PREPARED	NAME L. Pazmany	8-12-69	PAZMANY AIRCRAFT CORPORATION — SAN DIEGO — CALIFORNIA —	MODEL NO.	P-1
CHECKED			ENGINEERING CHANGE NOTICE #8	REPORT NO.	
APPROVED				PAGE NO.	1

DWG 1-20-003 - STABILATOR

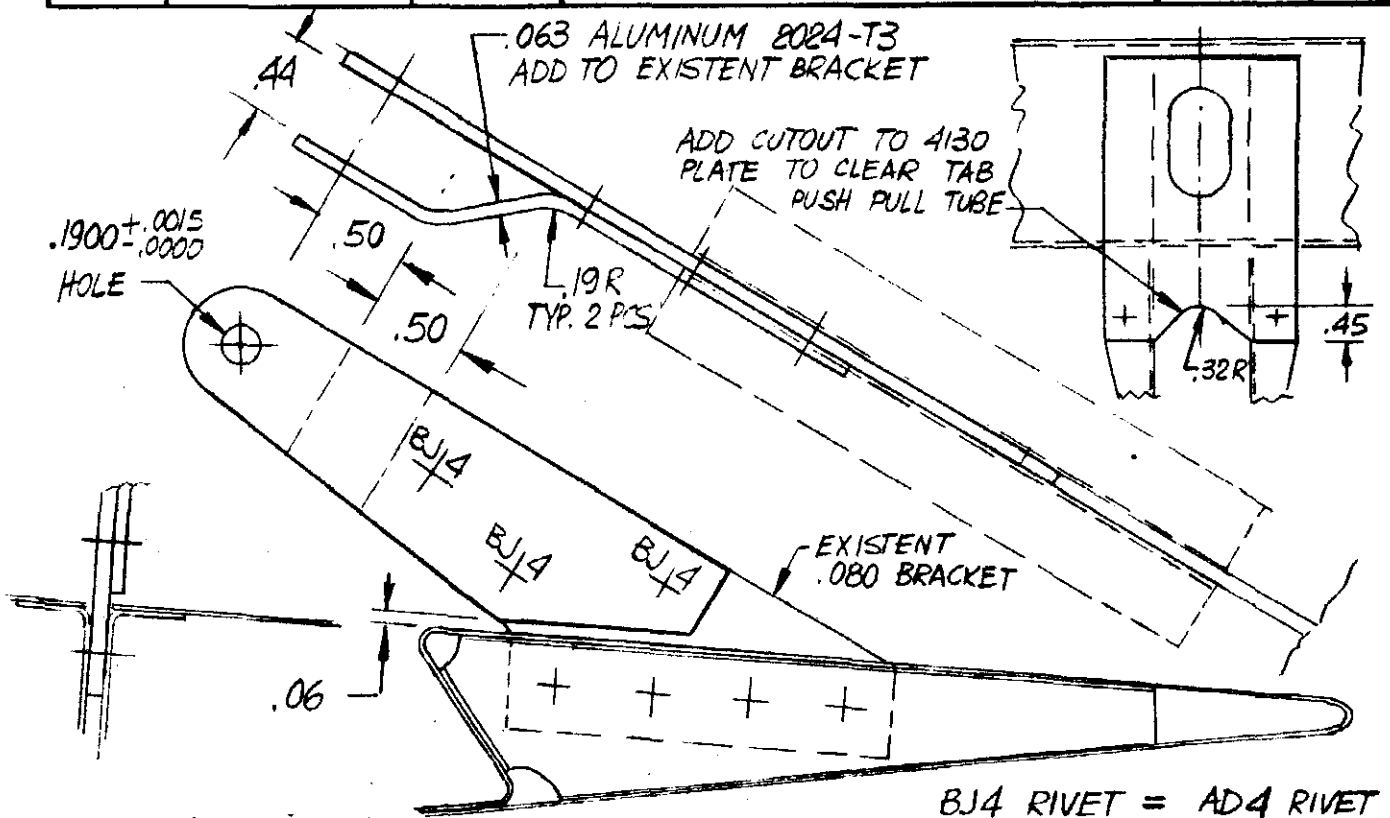
THE ADDITIONAL BRACKET FOR THE STABILATOR TAB SHOWN IN PAGE 1 OF THIS ECN IS A "FAIL-SAFE" DESIGN. WITH SO MUCH PUBLICITY GIVEN TO FLUTTER PROBLEMS IN STABILATORS USED IN SOME OTHER DESIGNS I WOULD LIKE TO SEE THIS SAFETY MEASURE IN ALL PL-1 AIRPLANES. FORTUNATELY THE PL-1 FLYING, SO FAR DID NOT SHOW ANY SIGN OF FLUTTER. THE MAXIMUM SPEED SHOULD NEVER EXCEED 175 MPH. THE STRUCTURE WAS STRESSED TO A HIGHER SPEED, BUT ONLY TESTED TO 175 MPH.

DWG 1-20-003 - STABILATOR

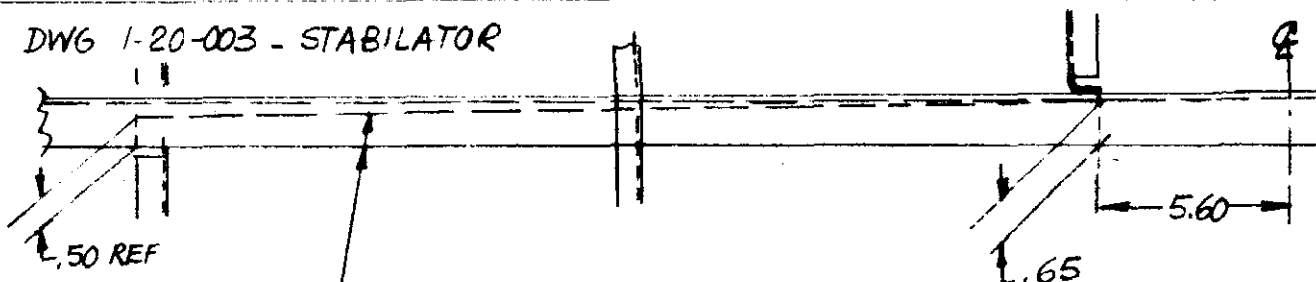
WIDTH OF STRAP TAPERS FROM .50 AT END TO .65 AT INBD RIB
